Leagram Mill Farm, Leagram

TN01 – Response to Lancashire County Council Highways

Client:	Kim Weld-Blundell	Job No:	J329380
Date:	05 February 2026	File Name:	TN01
Prepared by:	LJ	Approved by:	ME

Figure 3.1 : Proposed Site Access Arrangement

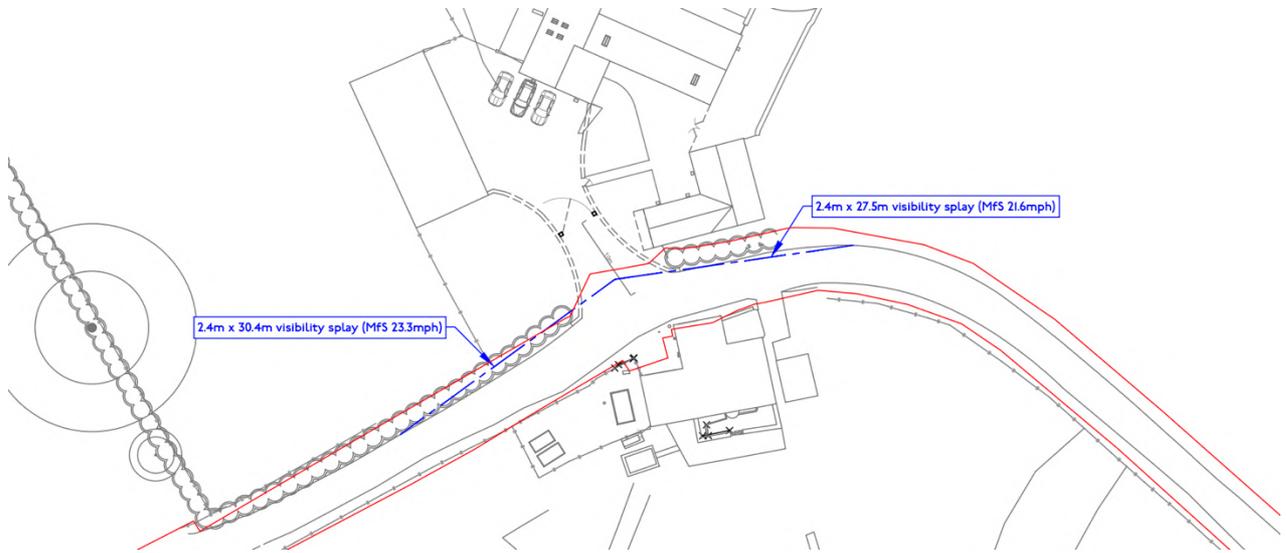
‘..... to ensure adequate intervisibility between highway users at a new access a visibility splay set 2.4 metres back from the near edge of the carriageway and extending 214 metres along the nearside carriageway edge in both directions should be provided.

The visibility splay should be wholly within the land which the applicant controls and/or the adopted highway and nothing shall be erected, retained, planted and / or allowed to grow at or above a height of 0.9 metres above the nearside carriageway level which would obstruct the visibility splay of the proposed access.

Or alternatively, reduced sight lines may be acceptable if the applicant can provide an observed traffic speed study, which indicates the 85th percentile traffic speeds are less than detailed above. The traffic study would need to be carried out by an approved specialist showing the 85th percentile wet road traffic speeds in both directions, the numbers of vehicles, types of vehicles and the speed of vehicles passing the access..... the proposed gates should be set further back into the site at 10m behind the carriageway edge. This is because the site will provide access to an agricultural building and as such, agricultural vehicles and trailers require further space to pull clear of the carriageway. The access shall be paved in a permeable hardstanding material for 10m into the site to prevent debris from being dragged onto the highway and drainage, collected within the site and drained to a suitable internal outfall, should be provided at the access point to prevent water from discharging onto the highway.'

The proposal will generate more car movements and drivers will not have the same clearance over vegetation as the existing agricultural vehicles using the site. As such to ensure adequate intervisibility between highway users at a new access a visibility splay set 2.4 metres back from the near edge of the carriageway and extending 214 metres along the nearside carriageway edge in both directions should be provided.

The visibility splay should be wholly within the land which the applicant controls and/or the adopted highway and nothing shall be erected, retained, planted and / or allowed to grow at or above a height of 0.9 metres above the nearside carriageway level which would obstruct the visibility splay of the proposed access.

Or alternatively, reduced sight lines may be acceptable if the applicant can provide an observed traffic speed study, which indicates the 85th percentile traffic speeds are less than detailed above. The traffic study would need to be carried out by an approved specialist showing the 85th percentile wet road traffic speeds in both directions, the numbers of vehicles, types of vehicles and the speed of vehicles passing the access.

Further amendments are required in regard to the access; the proposed gates should be set further back into the site at 10m behind the carriageway edge. This is because the site will provide access to an agricultural building and as such, agricultural vehicles and trailers require further space to pull clear of the carriageway. The access shall be paved in a permeable hardstanding material for 10m into the site to prevent debris from being dragged onto the highway and drainage, collected within the site and drained to a suitable internal outfall, should be provided at the access point to prevent water from discharging onto the highway.

3.2.2 Based on Manual for Streets (MfS) standards for the recorded 85th percentile speeds shown in [Table 3.1](#), visibility splays of 2.4m x 27.5m and 2.4m x 30.4m are required to the west and east respectively.

3.3.1 The proposed site access arrangement and required visibility splays for the recorded 85th percentile speeds are shown in [Figure 3.1](#), and in [Drawing J32-9380-PS-001](#) attached in [Appendix D](#).

3.3.2 Based on MfS standards for the recorded 85th percentile speeds shown in [Table 3.1](#), visibility splays of 2.4m x 27.5m and 2.4m x 30.4m are achievable to the west and east respectively in land under the control of the applicant and the adopted highway. The landscaping to the west of the proposed access will not exceed 0.9m above the carriageway level. The proposed gate has been set back into the site at 10m from the carriageway edge.

Project Name Leagram Mill Farm	Project No. 210.24	Stage Planning Submission
Proposed Site Plan 07	Scale 1:200 @ A1	Date September 2025
Rev. A	Drawn	RP

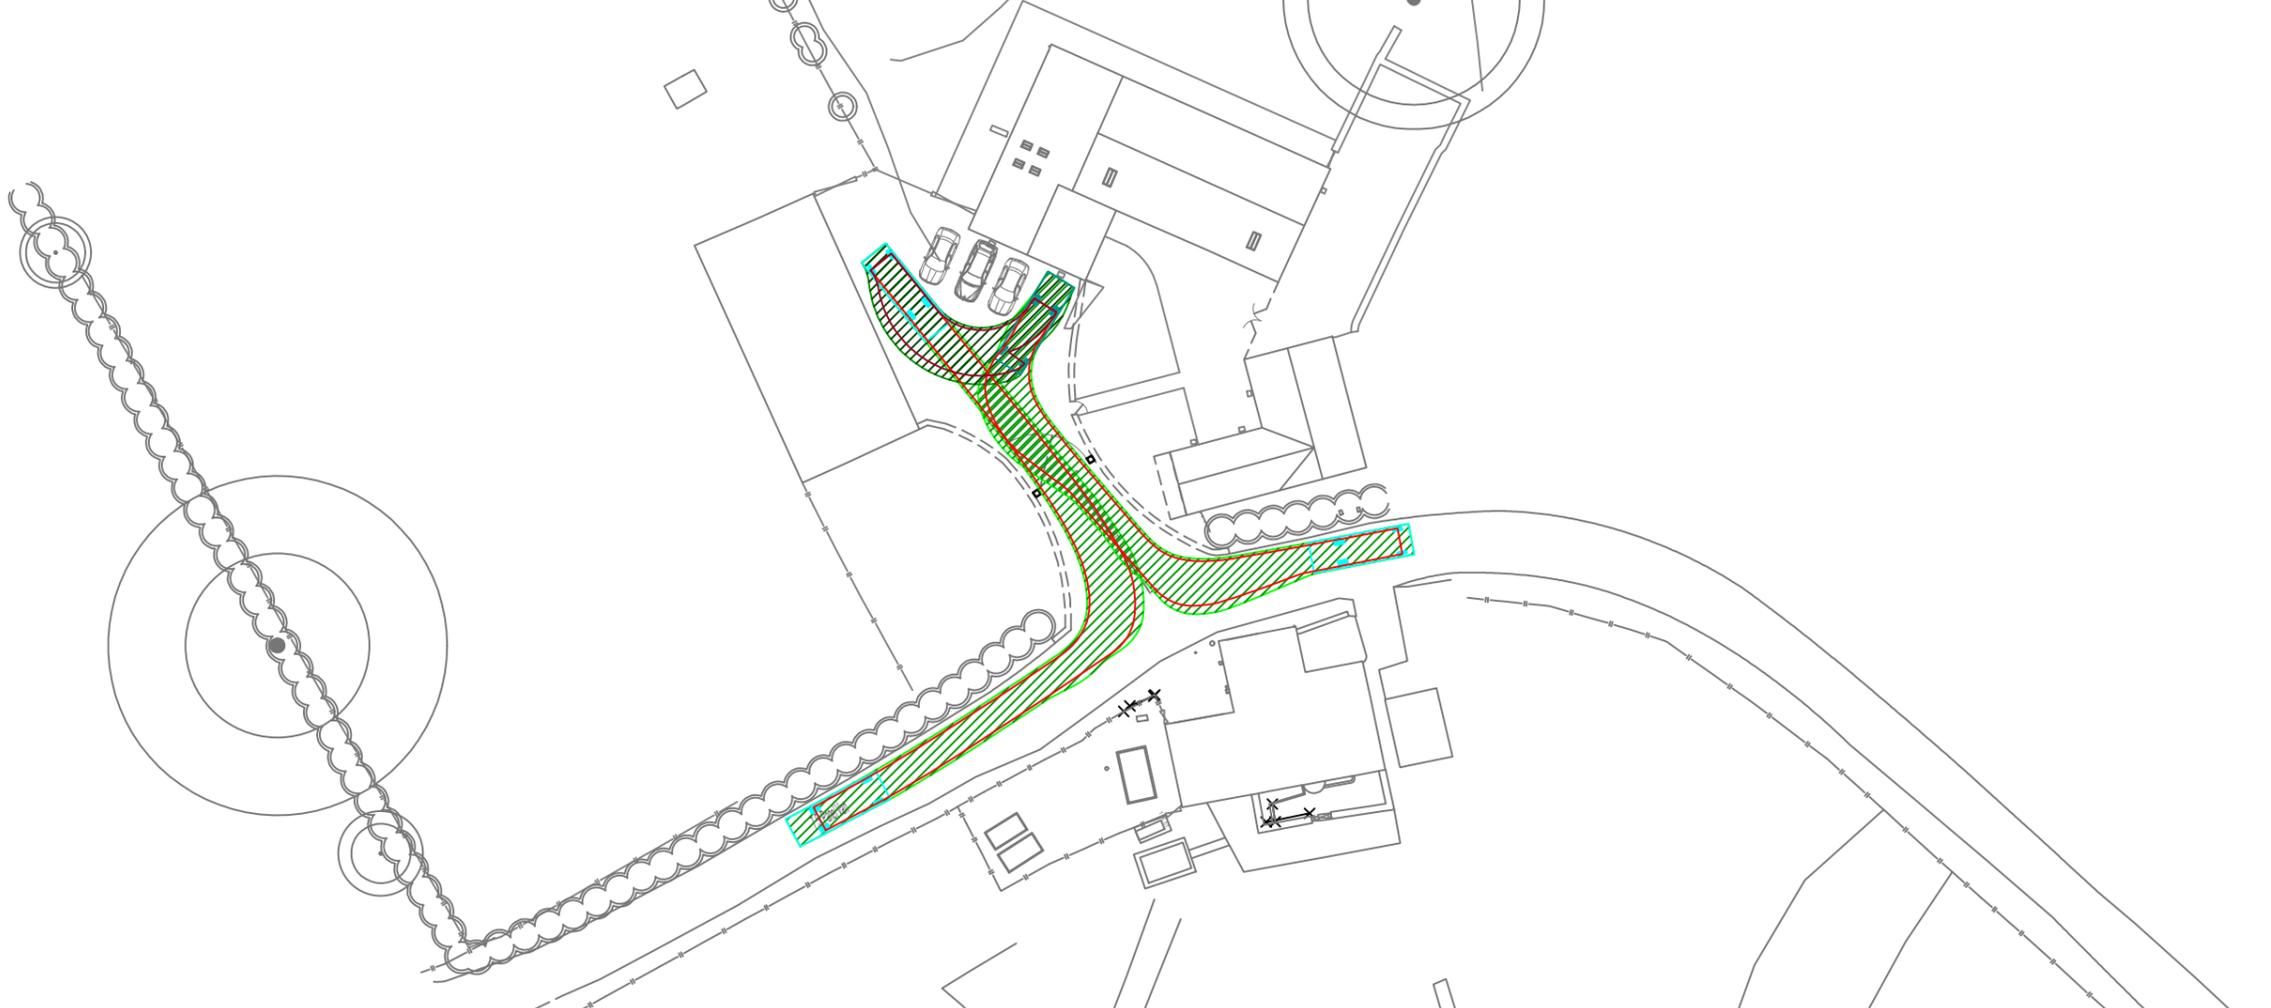
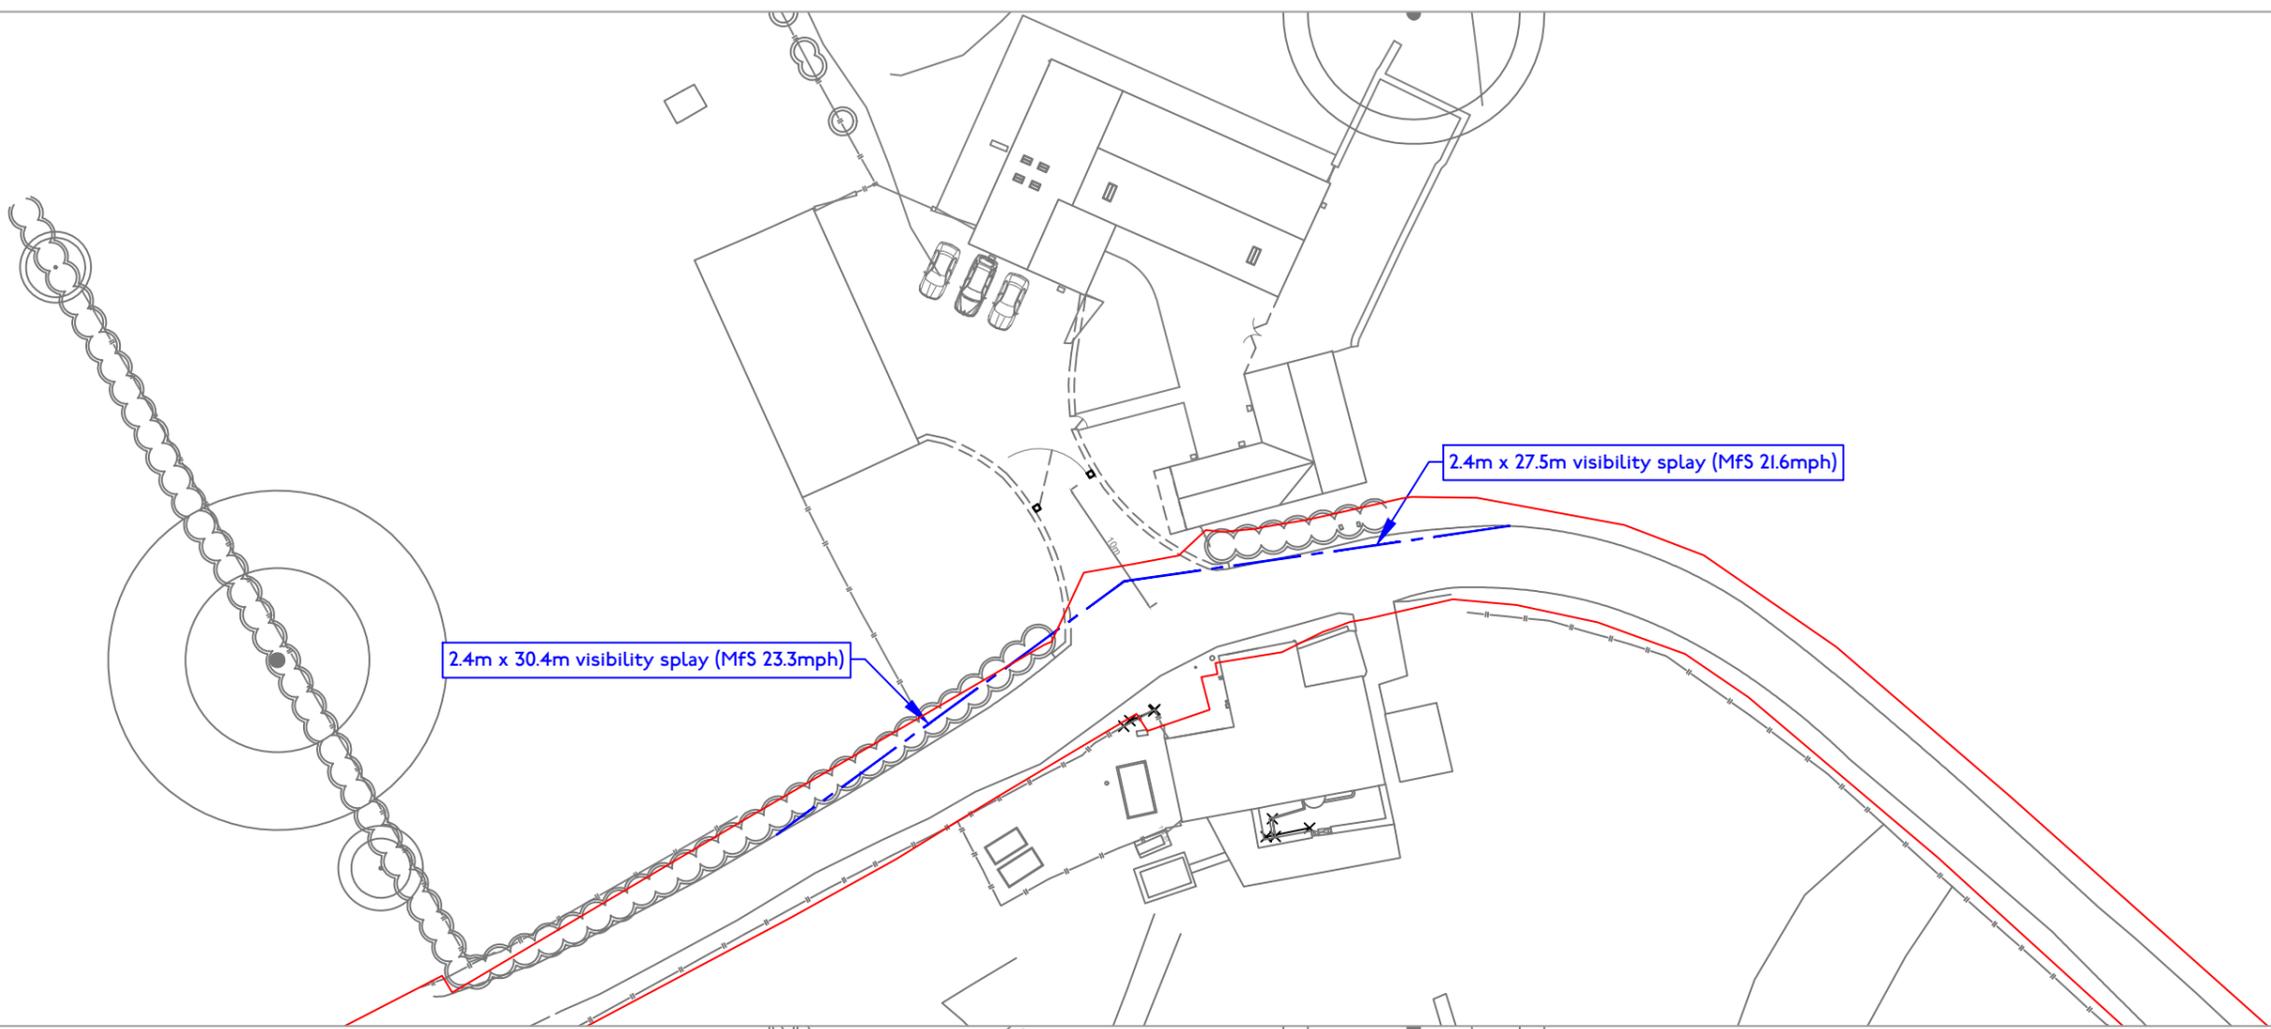
The site will be accessed via an amended existing access onto Dinkling Green Lane, classified as the C567, subject to a national speed limit. The access amendments include widening the existing access point to approximately 11m, the placement of a boundary wall around the access and gates set back approximately 9.5m.

The LHA have reviewed drawing number 07 titled Proposed Site Plan and are aware that the dwelling complies with the LHAs parking standards as defined in the Joint Lancashire Structure Plan.
